**HOPE CREEK GENERATING STATION**

**INDEPENDENT ASSESSMENT OF HOPE CREEK REACTOR  
RECIRCULATION SYSTEM AND PUMP VIBRATION ISSUES**

**November 12, 2004**

**Sargent & Lundy LLC**

**Exhibit 5-1.**  
**RR Pump A Vibration Trends**

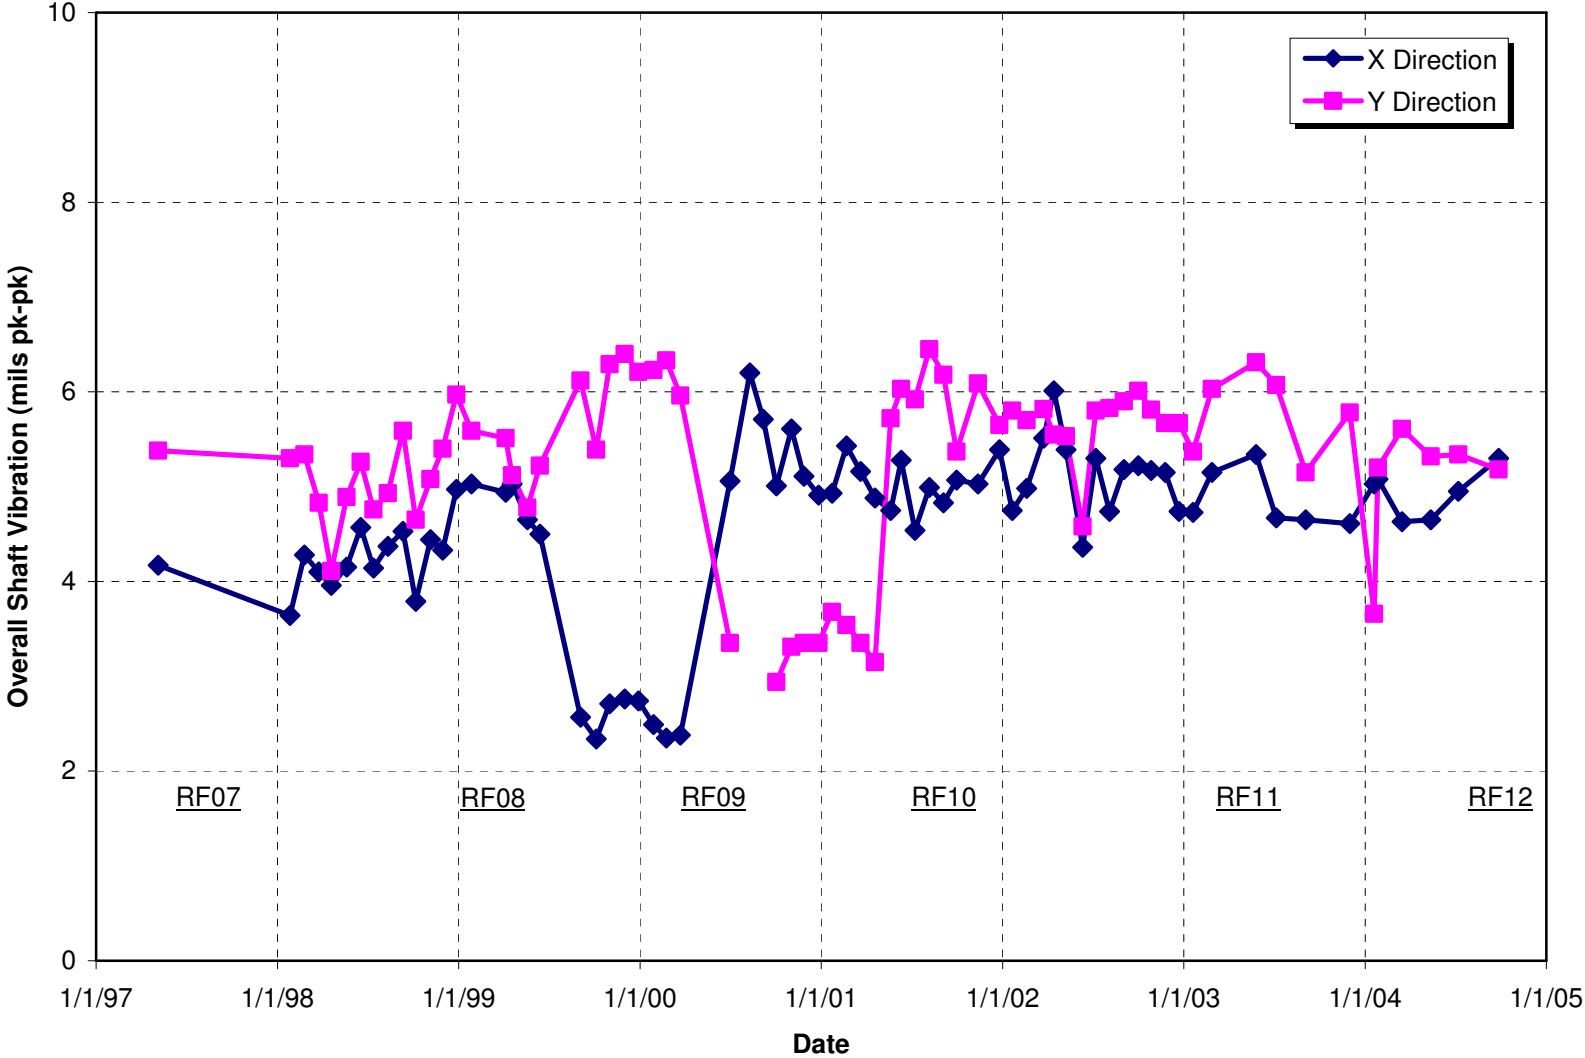
The "B" pump vibrations are approximately two times higher than the "A" pump vibrations. This is consistent with the "B" pump mechanical seals having reduced life and requiring more frequent replacement than the "A" pump mechanical seals. However, the RR pump vendor has indicated that the "B" pump vibration levels are acceptable and comparable to other plants. For comparison purposes, vibration data obtained for the RR pumps at Browns Ferry Unit 2 during power ascension is provided in Exhibit 5-3. The maximum shaft vibrations are 7 to 7.5 mils for the "B" pump and 9 to 9.5 mils for the "A" pump. Both of the Browns Ferry RR pumps have higher vibrations than the Hope Creek "A" RR pump. The most recent Hope Creek "B" RR pump vibrations are only slightly higher than the Browns Ferry "A" RR pump vibrations.

**Exhibit 5-2.**  
**RR Pump B Vibration Trends**

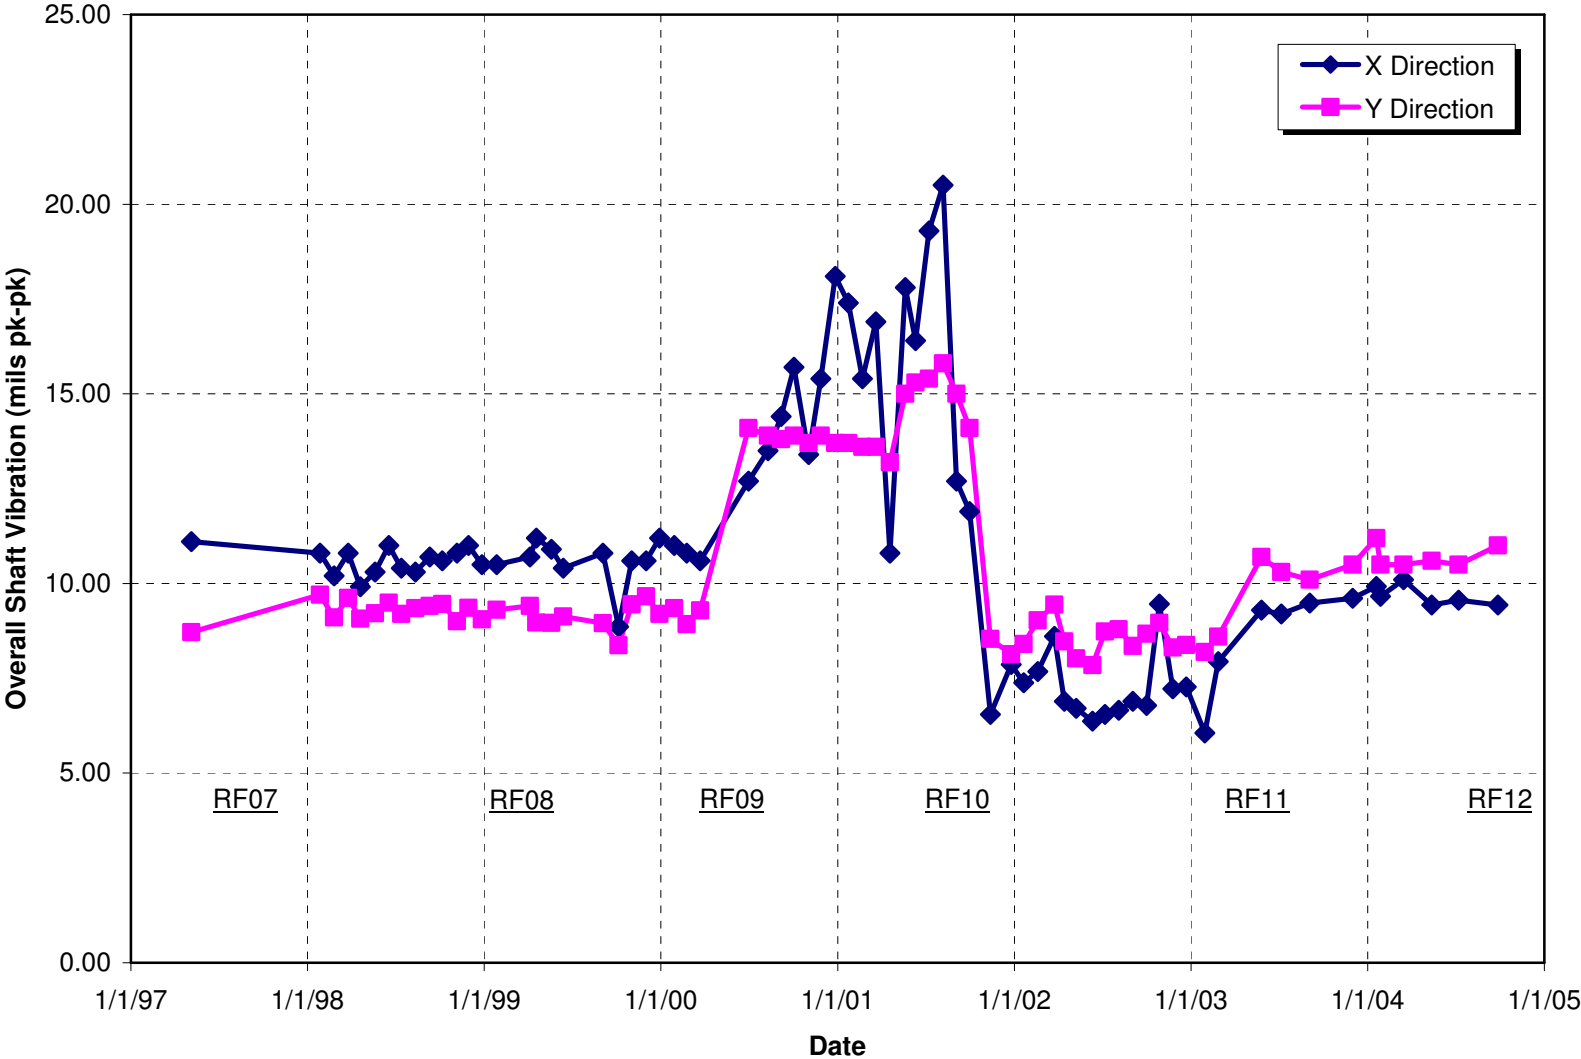
There is no trend of increasing vibrations for either RR pumps. Therefore, the vibration data does not indicate signs of degrading condition for either pump. The predominant 'B' RR pump shaft displacements occur at the pump running speed. This is consistent with unbalance or a bent shaft.
